Specification change: BA and BD series terminal blocks

IDEC would like to inform you of a few specification changes regarding our BA and BD series terminal blocks.

Marking change (BA811S):

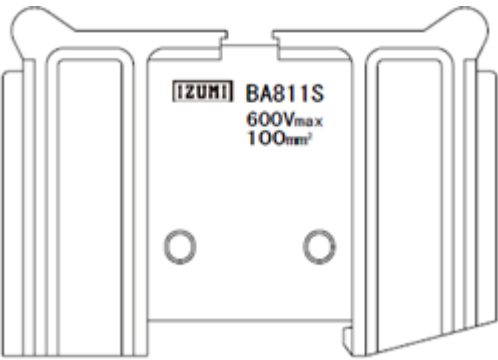
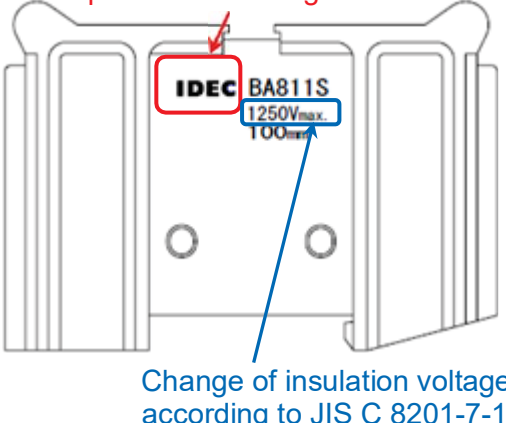
The markings of insulation voltage and IDEC logo will be changed as follows.

Current	New

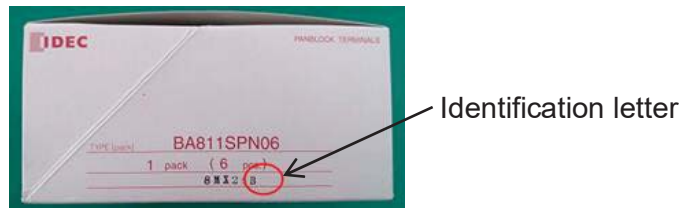
BA811S with new markings will have an identification letter “B” displayed at the end of the lot number on their product cases.
